DECISION OF THE PLANNING ADMINISTRATOR

URBAN GROWTH AREA PRELIMINARY DECLARATION / CLASS 3 SITE PLAN REVIEW / CLASS 2 DRIVEWAY APPROACH PERMIT CASE NO. UGA-SPR-DAP17-04

SUMMARY: An Urban Growth Area Preliminary Declaration to determine the public facilities required for development of 3 acres and a Site Plan Review and Driveway Approach Permit for a towing company building and vehicle storage area located at 4350 Ridge Drive NE.

**URBAN GROWTH AREA PRELIMINARY DECLARATION /
SITE PLAN REVIEW / DRIVEWAY APPROACH PERMIT
CASE NO. UGA-SPR-DAP17-04
DECISION**

1 SITE PLAN
1" = 20' 0"

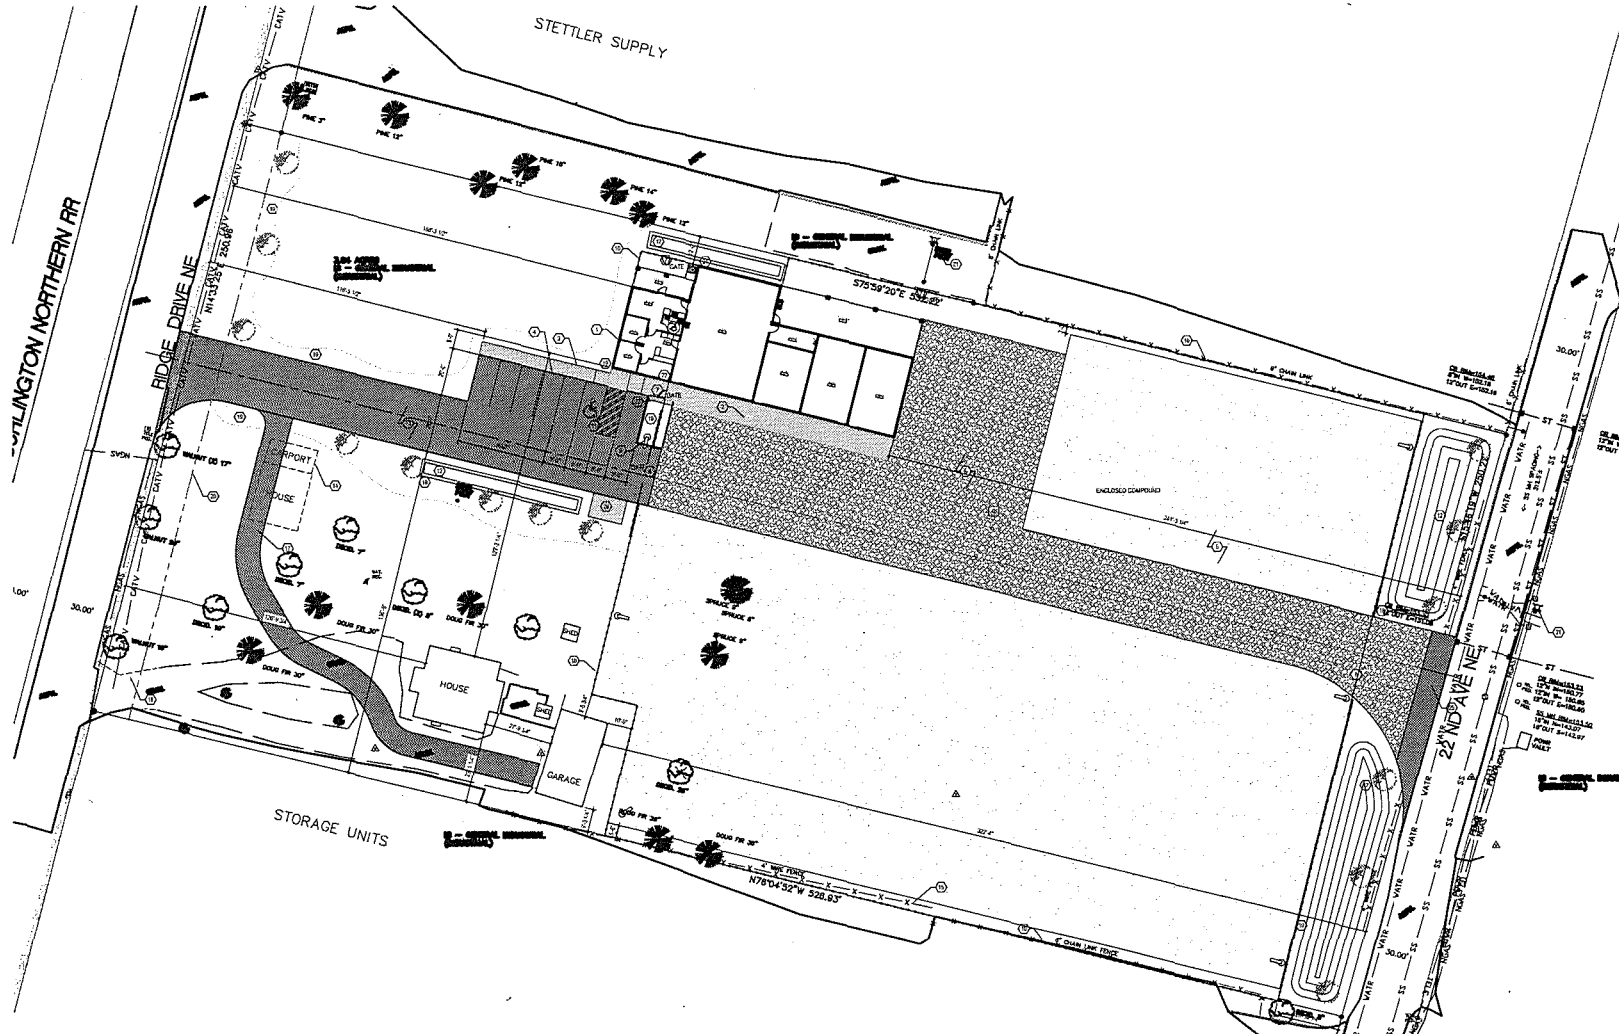
Finding: The interior driveway proposed for the off-street parking area does not conform to the driveway location and dimensional requirements of SRC 806.040 because there is a single driveway but there is no turnaround or loop. To comply with the requirements, the following condition is necessary:

Staff Response: The site plan did not include full plans for the solid waste service area. Compliance will be verified at building permit.

Staff Response: The site plan indicates a vehicle operation area meeting the standards for receptacles of 2 cubic yards or less. If larger containers will be used, the vehicle operation area must be perpendicular to the front opening of the enclosure. Compliance will be verified at building permit.

Staff Response: The site plan indicates a vehicle operation area parallel to the opening of the enclosure. With the proposed configuration, a vehicle would be able to back up into the driveway that leads to the caretaker dwelling in order to turn around. Compliance will be verified at building permit.

Staff Response: The site plan indicates a vehicle operation area location that would not require backing onto a public street or leaving the premises. With the proposed location of the solid waste service area, a vehicle would be able to back up approximately 125 feet into the driveway that leads to the caretaker dwelling in order to turn around. However, the proposed design of the caretaker driveway does not appear to provide a turning radius that would be sufficient for a large vehicle. In order to ensure compliance with the standards at building permit, the following condition is required:

Staff Response: The applicant's site plan includes an uncovered solid waste service area 10 feet deep by 14 feet wide with a 4-inch-thick concrete pad and screened with a 6-foot chain link fence with vinyl slats. The location of the service area is acceptable if containers are 2 cubic yards or smaller.

Finding: The driveway approach configurations provide sufficient width to accommodate truck turning movements into the subject property. The applicant shall provide turning radii on both sides of the driveway approaches. To ensure compliance with this standard, the following condition is required:

Condition 3: Provide a paved turnaround area for the proposed parking area.

Condition 5: Provide a paved turnaround with an adequate width and turning radius for solid waste service vehicles.

Condition 6: Provide a solid waste service area meeting the standards of SRC 800.055.

Condition 7: Provide a radius along the north line of the driveways pursuant to PWDS. The southerly driveway approach on Ridge Drive NE shall be closed, as shown on the application materials.

SITE PLAN

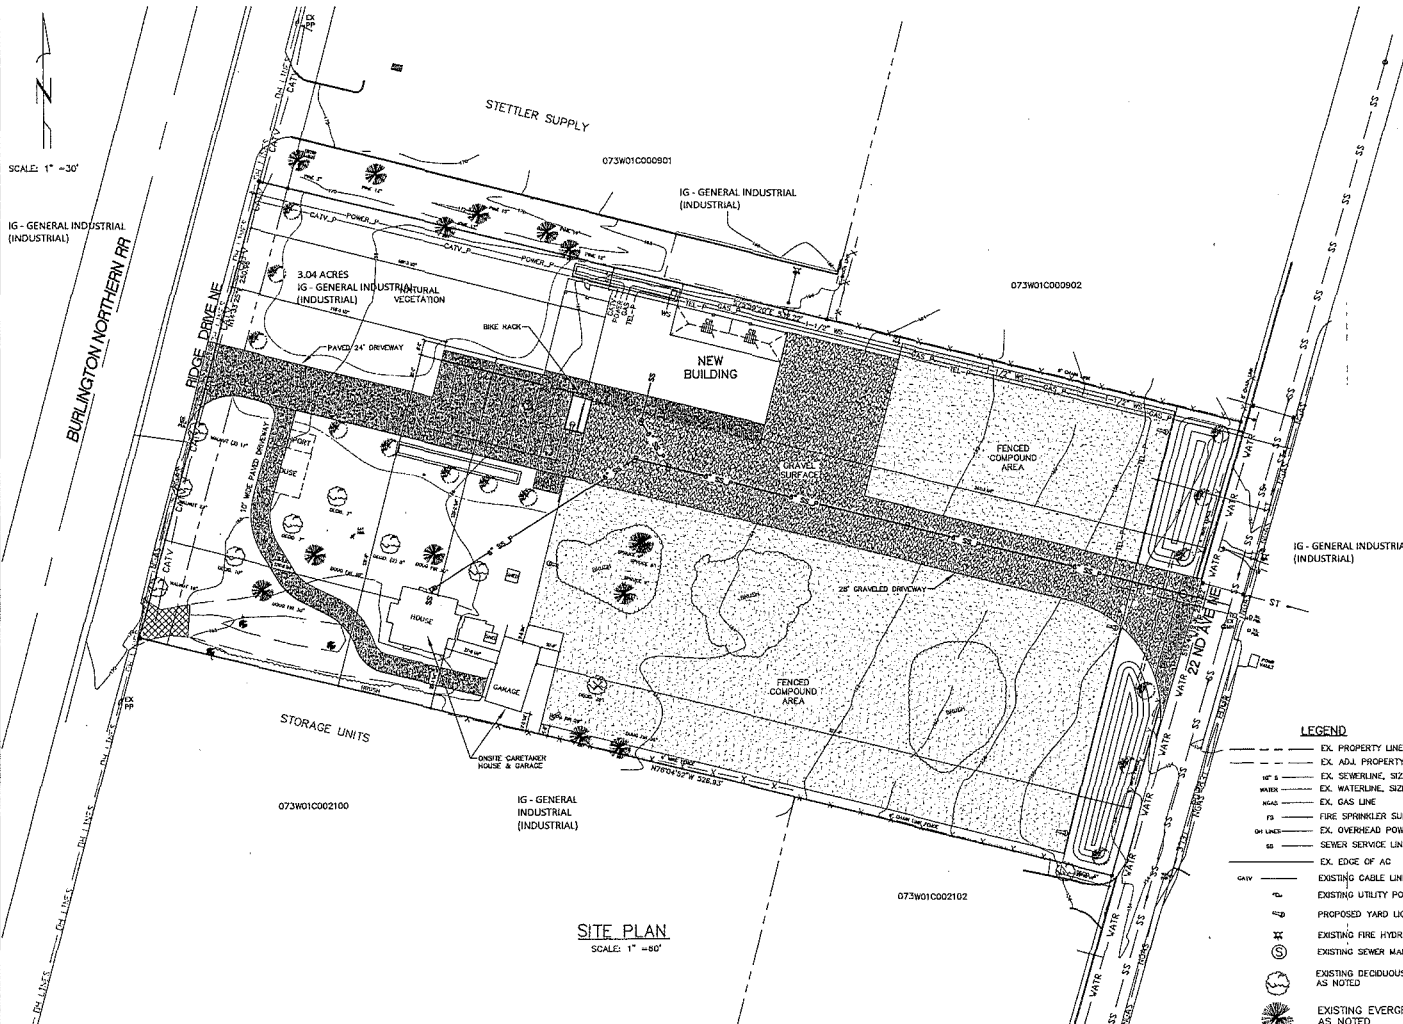
Finding: The Public Works Department has reviewed the applicant's preliminary utility plan for this site. The water, sewer, and storm infrastructure are available within surrounding streets / areas and appear to be adequate to serve the proposed development. The applicant shall design and construct all utilities including sewer, water, and storm drainage according to the PWDS and to the satisfaction of the Public Works Director. The applicant is advised that a sewer monitoring manhole may be required, and the trash area shall be designed in compliance with Public Works Standards.

The proposed plan demonstrates compliance with PWDS Appendix 4E related to green stormwater infrastructure by setting aside at least ten percent of the total new impervious surface area for installation of green stormwater infrastructure. The applicant's engineer shall design and construct a storm drainage system at the time of development in compliance with SRC Chapter 71 and PWDS.
